From: [Perkins, Matthew](#)
To: karen.walter@muckleshoot.nsn.us
Cc: [Overton, Frank](#); [Lindsey Ozbolt](#); [Peterson, Bob](#); [Brown, Kevin](#); [Auld, Gina](#)
Subject: Letter RE: ELST Segment 2B
Date: Monday, February 13, 2017 1:56:03 PM
Attachments: [February 13 - Letter - Karen Walter - ELST Segment 2B.pdf](#)
[Attachment 1.pdf](#)
[Attachment 2.PDF](#)
[Attachment 3.PDF](#)

Thank you for submitting comments pursuant to the East Lake Sammamish Segment 2B Shoreline Substantial Development Permit (SSDP2016-00415). I am sorry to hear that there was difficulty in accessing some of the supporting information. I am recapping some of our previous communications in this letter, providing updated links to some of the files for review, and offering another opportunity to meet to go over all of the information.

EAST LAKE SAMMAMISH MASTER PLAN TRAIL SOUTH SAMMAMISH SEGMENT B
 SAMMAMISH, WA

SHEET NO.
118 OF 135
LA6

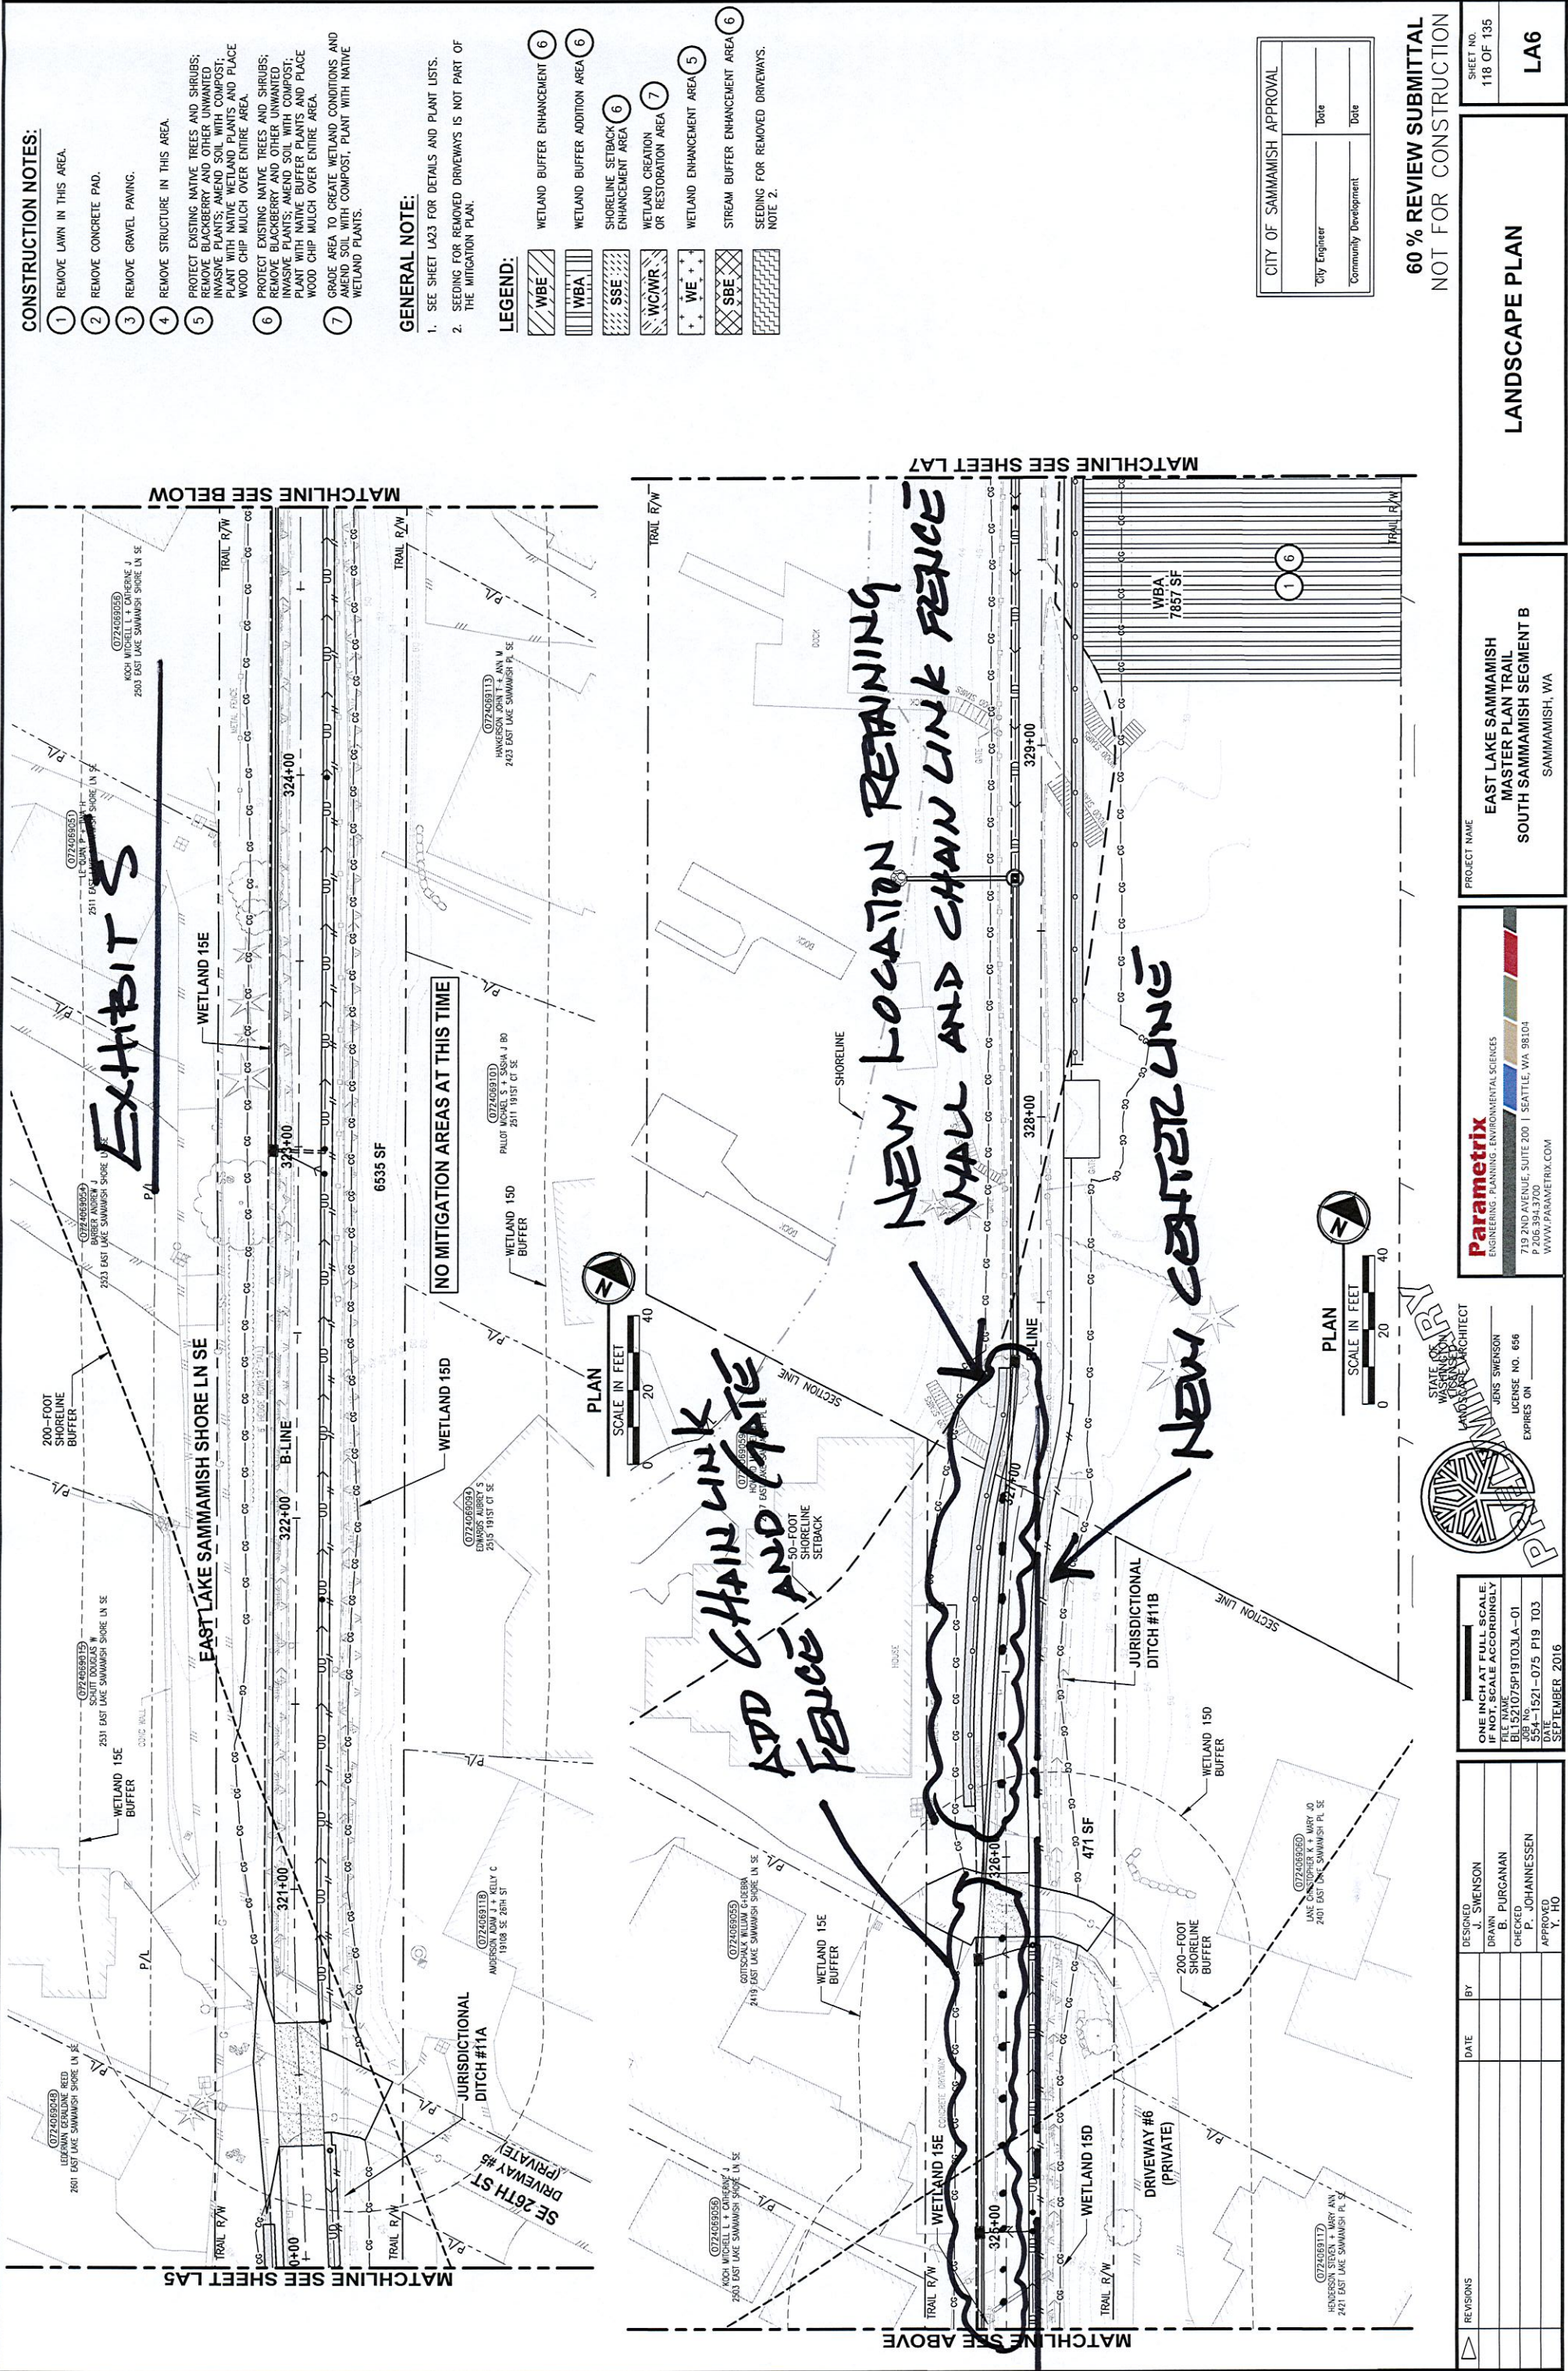
ADD CHAIN LINK FENCE AND GATE
